# Access Compliance Report

## Public Rights-of-Way

Intersection ID: 19209	Main Street: LIVINGSTON_DR	Cross Street: SARDIS_RD	Location: NW
ADA ID: 9402B9FF6F50	Ramp Type: Perp	Initial Pass/Fail: Fail	Overall Compliance: No
Codes/Mitigation Info/Possible Solution		Field Measurements/Component Compliance	
Severity Score: 13.75

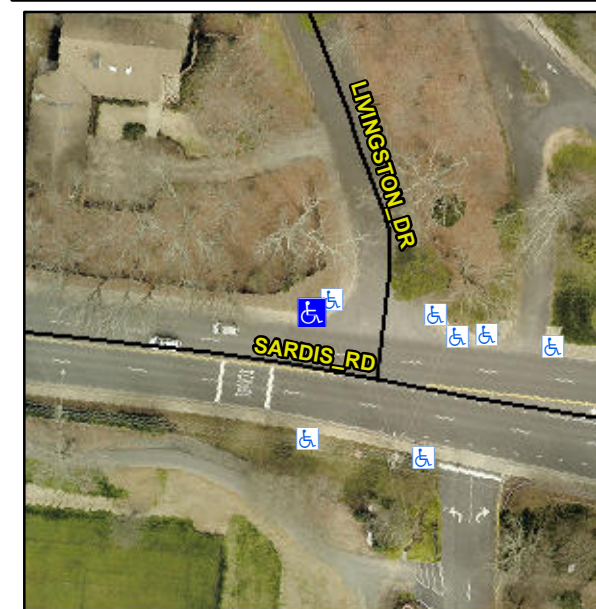
**Not Found, R304.2.2, R304.5.3**

Compliance	Description	Data	Compliance	Description	Data
N/A	Ramp Length (in)	57.0	No	Ramp Slope (%)	9.8
Yes	Ramp Width (in)	48.0	No	Ramp XSlope (%)	3.2
N/A	Flare Type LT	N/A	N/A	Flare Type RT	N/A
N/A	Flare Slope LT (%)	N/A	N/A	Flare Slope RT (%)	N/A
N/A	Flare Traversable LT?	N/A	N/A	Flare Traversable RT?	N/A
N/A	Landing Length (in)	N/A	N/A	DWS Provided?	N/A
N/A	Landing Width (in)	N/A	N/A	DWS Contrast?	N/A
N/A	Landing Slope (%)	N/A	N/A	DWS Length (in)	N/A
N/A	Landing X Slope (%)	N/A	N/A	DWS Full Width?	N/A
N/A	Landing Curb? (Y/N)	N/A	N/A	DWS Offset (in)	N/A
N/A	Shared Landing?	N/A			
N/A	Gutter Ponding?	N/A	N/A	Gutter Slope (%)	N/A
N/A	Gutter Lip Ht (in)	N/A	N/A	Gutter X Slope (%)	N/A
N/A	Painted X Walk1?	No	N/A	Painted X Walk2?	N/A
	X Walk 1 Direction	To S		X Walk 2 Direction	N/A
N/A	X Walk 1 Width (in)	N/A	N/A	X Walk 2 Width (in)	N/A
	X Walk 1 Slope (%)	3.2		X Walk 2 Slope (%)	N/A
	X Walk 1 X Slope (%)	0.2		X Walk 2 X Slope (%)	N/A

**Remove & Replace Entire Ramp.**
